ASSESSMENT REPORT			
<b>Unique Document ID and Revision No:</b>	ONR-OFD-AR-19-016 Revision 0	<b>TRIM Ref:</b>	2019/142779
<b>Project:</b>	Hinkley Point B Reactor 3 Periodic Shutdown		
<b>Site:</b>	Hinkley Point B		
<b>Title:</b>	Assessment of EC 365309 Hinkley Point B Reactor 3 2019 Graphite Core Inspection Results and Justification for Return to Service		
<b>Nuclear Site Licence No:</b>	62C		
<b>Licence Condition(s):</b>	LC 30		
<b>ONR Assessment Rating (Mandatory):</b> <i>(Rating should be based on licensee's original safety case submission)</i>	Green		
<b>COIN Service Order:</b>	SVC4285368

**Hinkley Point B Reactor 3 Periodic Shutdown 2019 – Graphite Structural Integrity  
Assessment**

Assessment Report ONR-OFD-AR-19-016  
Revision 0  
23 May 2019

Figure 1. H31 layer 4 brick visual and PECIT scans (2019)

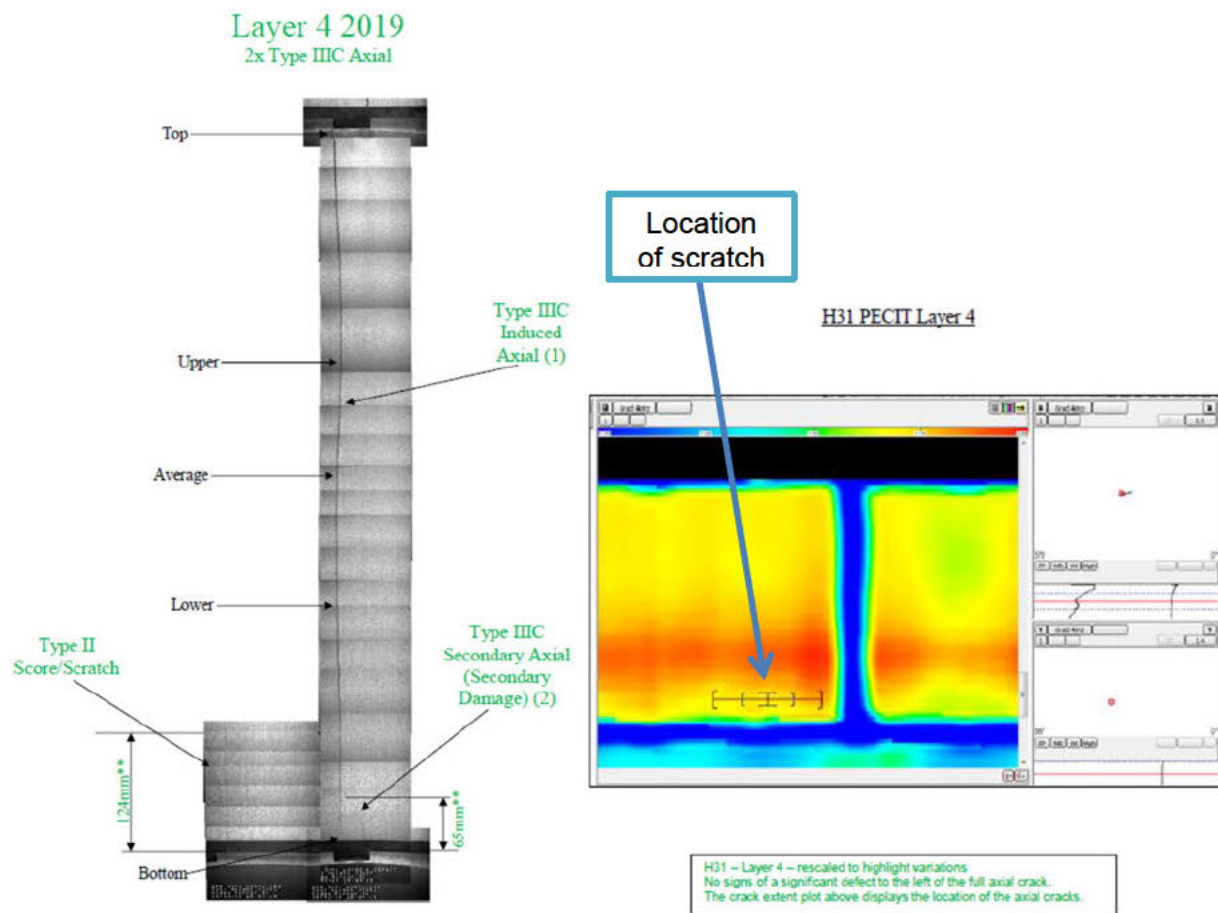
56. The Eddy Current results of the 13 channels inspected using the Prototype Eddy Current Inspection Tool (PECIT) do not appear to challenge the visual findings. In one case, additional support had been provided by PECIT to sentence what appeared to be a minor crack in channel H31 layer 4 shown in Figure 1. As PECIT indicated that the crack did not extend or open, it was sentenced as a surface scratch.

Figure A1.1. Observed defects in fuel channel S13 (HPB R3 2019)

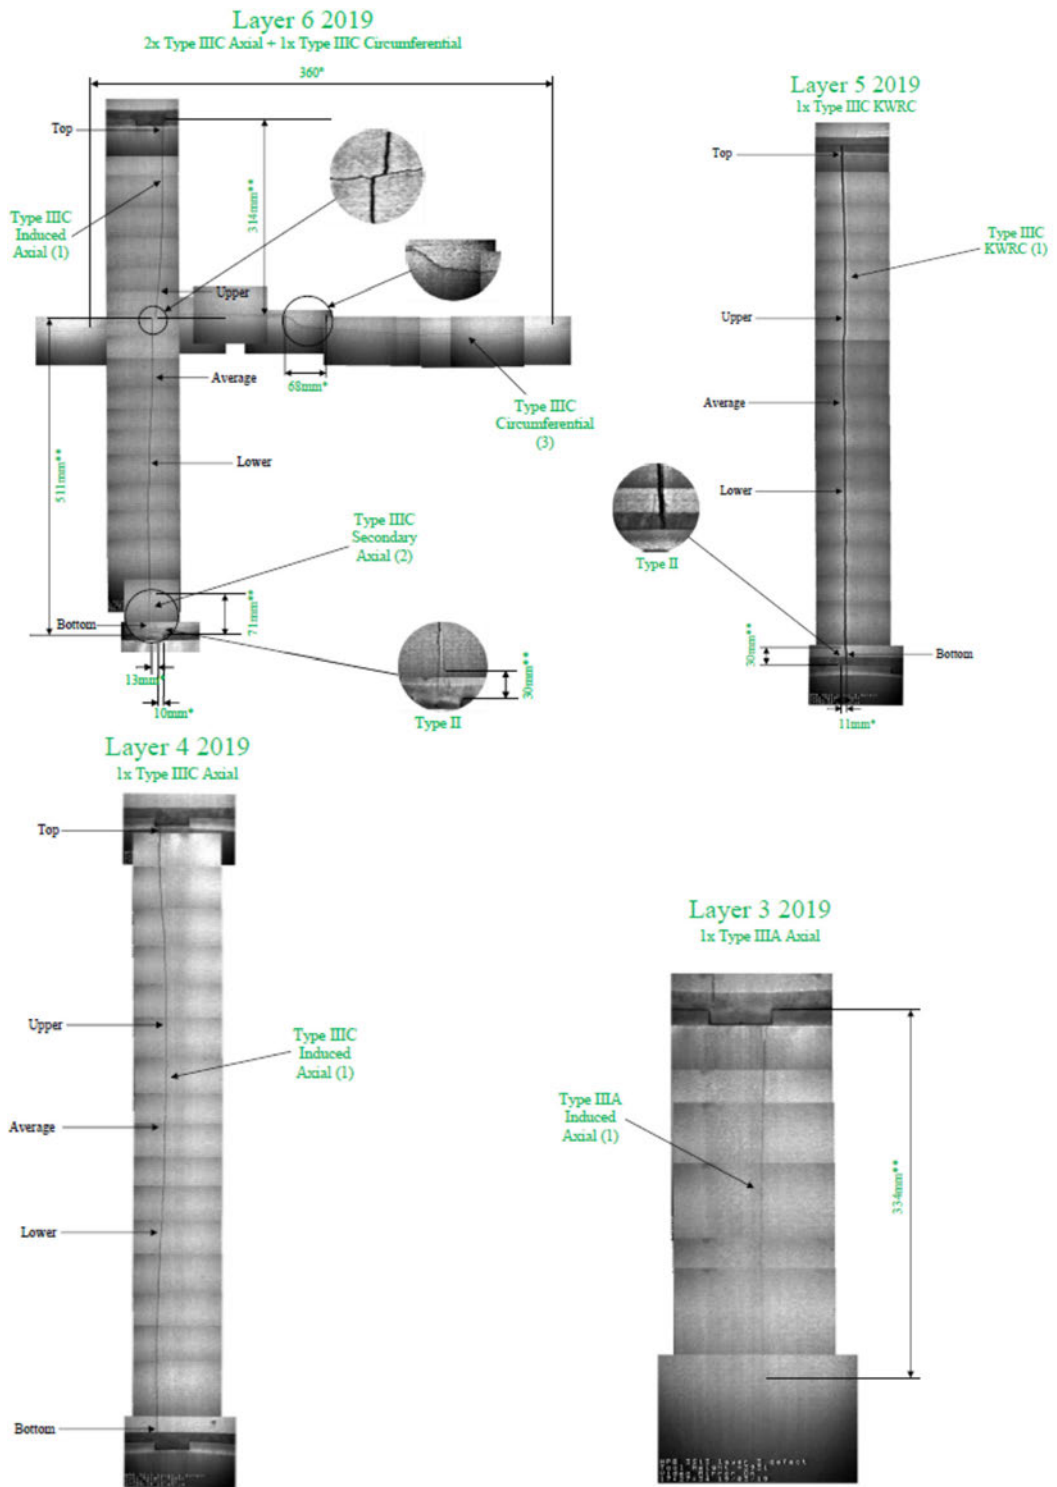
Figure A1.1 shows those defects. NGL sentenced the full height axial crack in brick layer 5 as a KWRC which has induced the other axial cracks. The circumferential crack in brick layer 6 was sentenced as a bore crack. I consider the sentencing to be in line with NGL's sentencing tree. However, in my opinion, the axial crack in brick layer 6 may not have conclusively been induced by the KWRC in brick layer 5 due to the cracks locations and the secondary damage to the end-face key at the bottom of the crack in brick layer 6. This highlights the potential difficulties in the classification of some cracks (because the timing of cracking is not known for some bricks) and hence there is some inevitable uncertainty in sentencing.

Figure A1.2. E33 KWRC in layer 7 and its cardioid plot

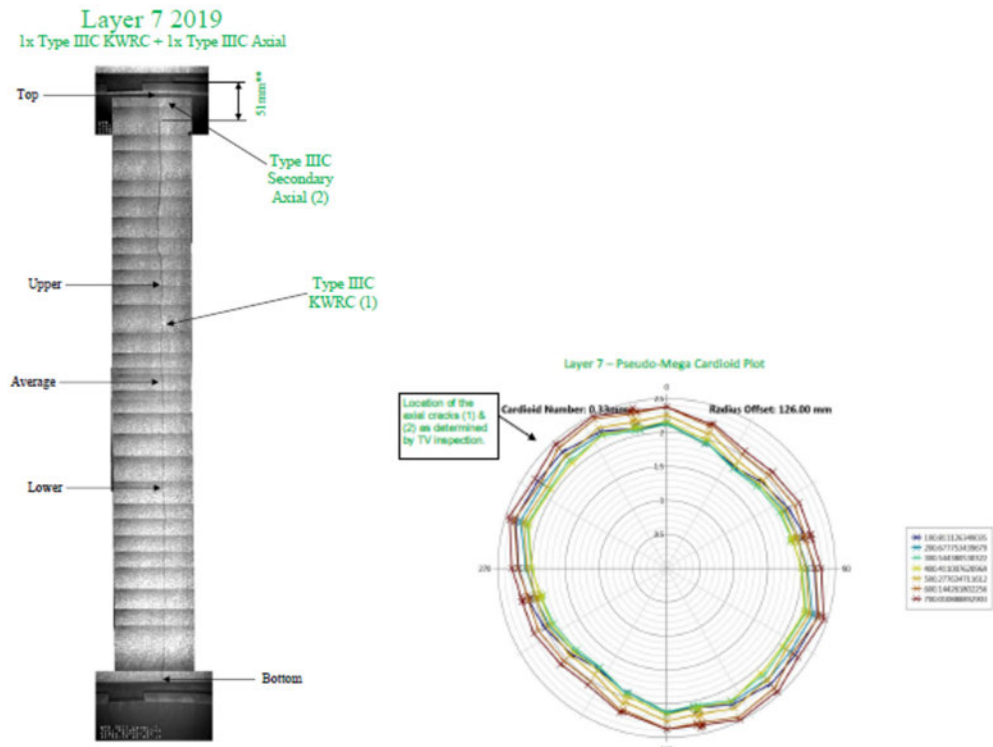
Edge and near edge channels are expected to receive lower irradiation dose as opposed to the central channels as the flux is lower towards the boundaries of the core. The combination of a KWRC brick in layer 7 and a doubly bore cracked brick in layer 5 is surprising, because the layer 5 brick would be expected to have received a higher irradiation dose than the layer 7 brick. However, because this channel had not been inspected previously, it is not possible to know the age of the cracks. However, the cardioid plot of the doubly cracked brick in layer 5, illustrated in Figure A1.3, shows a distinctive lipping indicative of bore cracking. This distinctive shape is missing from the cardioid plot of the layer 7 brick, as shown in Figure 2, which was sentenced as a KWRC. I consider the sentencing of those cracks to be reasonable and aligned with NGL's sentencing tree.
